SKEP III Home Office Support Site Visit Report

Consultant	Wahib Medanat Consultant Engineer	Rep No.	12-04072021
Contractor	Derar Saraireh & Sons for Engineering & Contracting	Tender No.	(11/2019/USAID/SKEP/3/S) Schools for a Knowledge Economy Project (SKEP) - Phase (3) Package (1, 2)
Site Name	Al Khansa' Basic Mixed School- Al Balqa	Day/ Date	Sun. 04/07/2021
Duration of Project	450 Calendar Days	Total Project Budget	9,789,417.840 JD

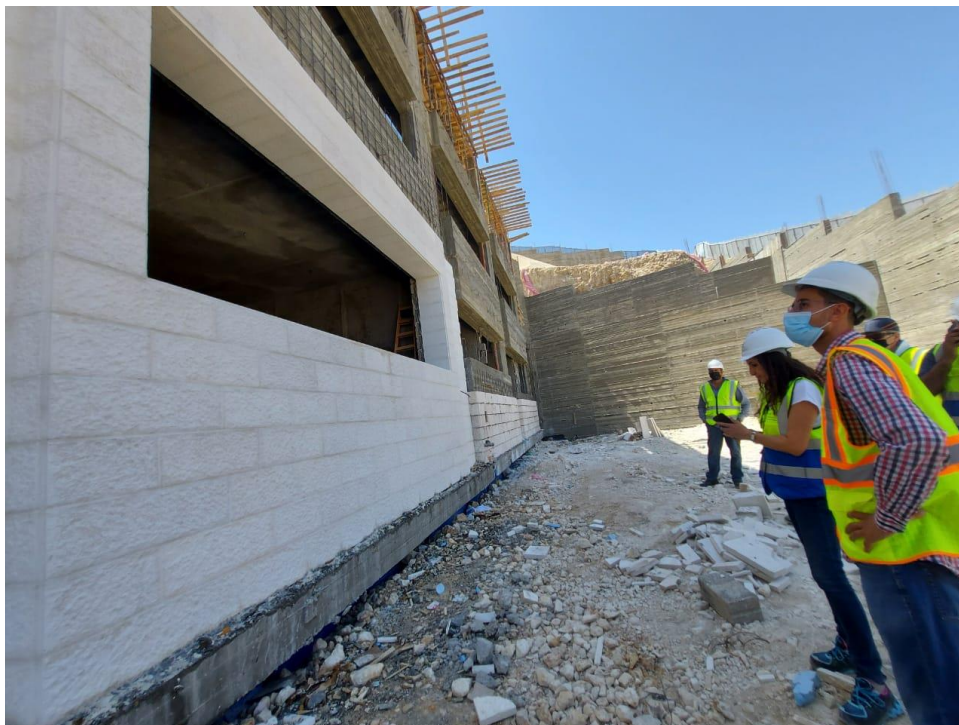
Temperature check, sterilization and signing visitors' attendance sheet at the entrance of the site, complying with Covid-19 Protocol
